State Significant Development 7664

Horsley Drive Business Park Stage 2

Section 4.55 (1A) Modification Application
(Mod No. 2)

Submitted to Department of Planning and
Environment

Figure 9 Proposed Elevations (South and West) – SSD-10404-Mod-1

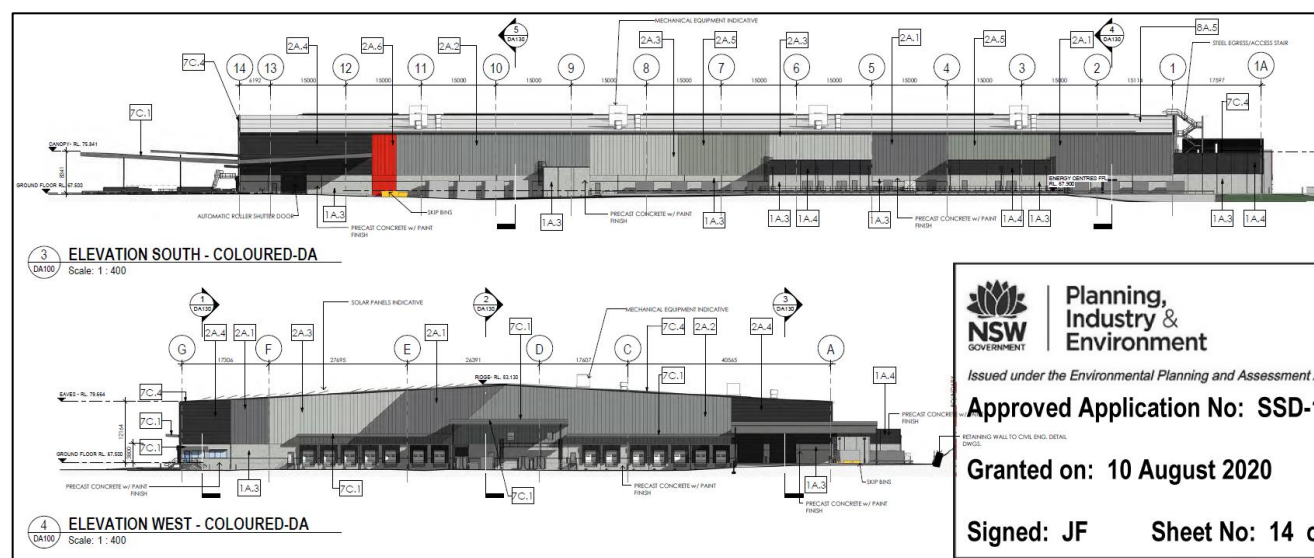
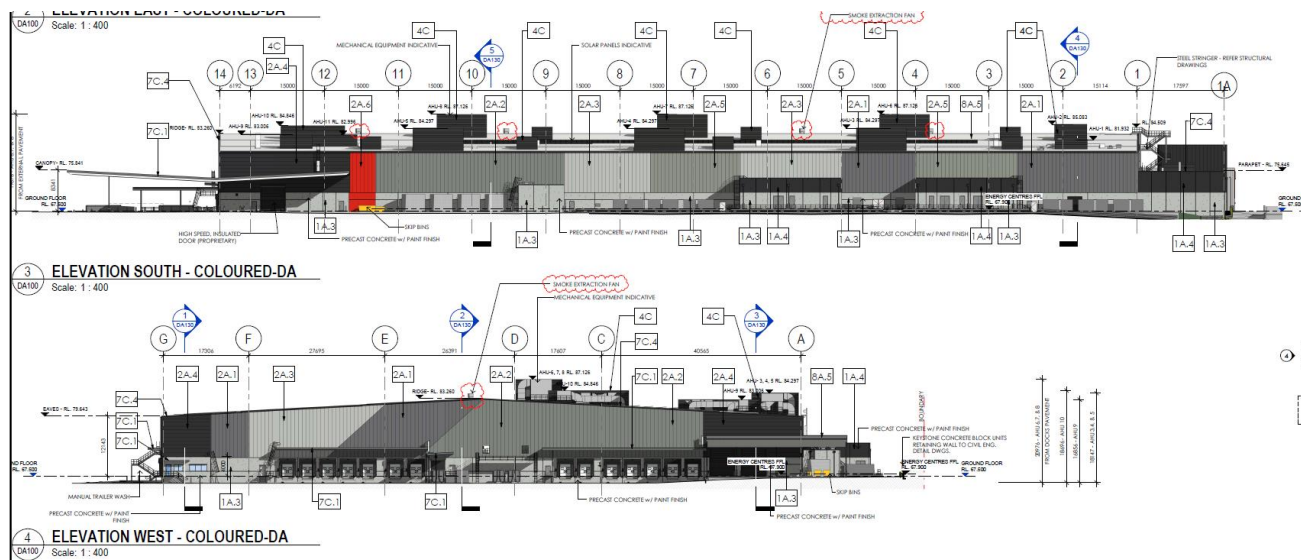
Part of these detailed design amendments include the placement of large air conditioning condensers on the roof of the building to ensure the building can be cooled and so freezer rooms can operate. The size of the building necessitates quite large condensers and other plant equipment which comprises heights up to 6m.

Mechanical engineers have advised that the plant equipment and condensers cannot be located within the building or at ground level and must be placed on the roof for optimal operation and maintenance. As such, flexibility in the way building height is calculated is requested, so that rooftop plant and lift overruns are excluded from the maximum 16m building height conditioned by SSD 7764. The increase in building height is not intended to be a blanket increase for all buildings within the Horsley Drive Business Park Stage 2. All buildings will still need to ensure the highest point of the building (excluding plant and lift overruns) does not exceed 16 metres about natural ground level.

The approved elevation for Building 1 (SSD-10404) is shown in **Figure 8** and the proposed modification to the Building 1 elevation to incorporate rooftop plant equipment (subject to a concurrent modification - SSD-10404-Mod-1) is shown in **Figure 9** below. A complete set of amended Architecture Plans are attached in **Appendix A** to illustrate the scope of proposed changes to the built form which will be facilitated via a concurrent section 4.55(1A) modification to SSD-10404.
